Service Bulletin

Amateur Radio Division

ASB-1030

Subject: TS-50S "HELLO" Displayed during TX

Final Unit (X45-3460-00) (B/2)
Foil side View

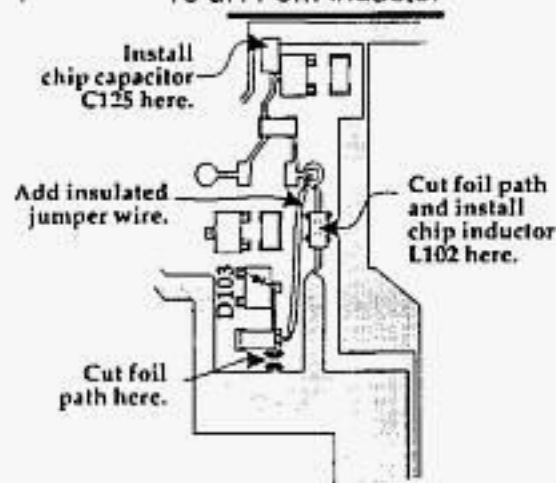
Occasionally an "HELLO" message will appear in the display of the transceiver when the TS-50S is loaded into an antenna without the use of an antenna tuner. This symptom usually occurs when the negative terminal of the power supply is floating (un-grounded for RF). This can result in RF feedback that causes the supply voltage to exceed 16 vdc.

1. Cut the Final Unit PC Board foil in two places, as shown below.
2. Add a .1uF chip capacitor (C125) as shown below.
3. Add a 10 uH chip ferri-inductor (L102) as shown below.
4. Add an insulated jumper wire as shown below.

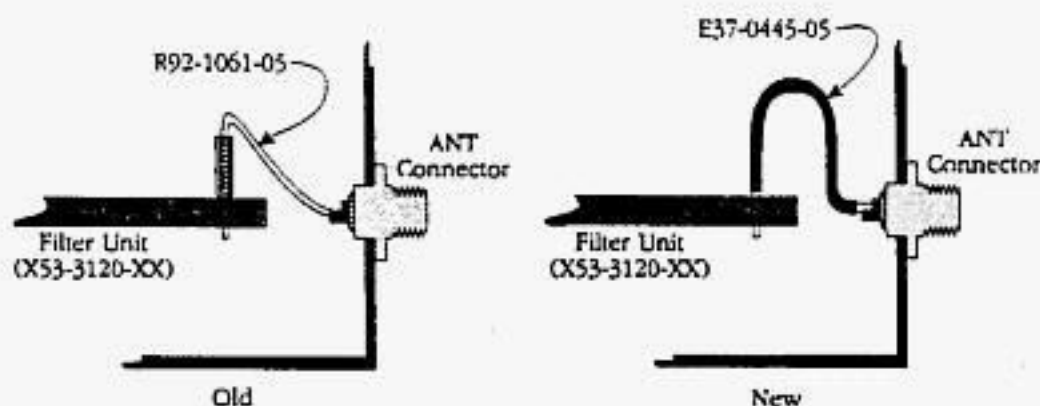
Several users have reported a problem with the antenna lead connection, i.e. the lead that connects the antenna connector to the Filter Unit (X53-3120-XX). Originally this connection was made by a zero ohm resistor. If excessive stress is placed on the antenna connector this lead is easily broken, with a resulting loss of receiver sensitivity and transmitter power. The use of a small flexible jumper wire will increase the flexibility of this connection, thus minimizing the effects of mechanical stress.

Remove the zero ohm resistor and replace it with the small piece of cable. See accompanying diagram.
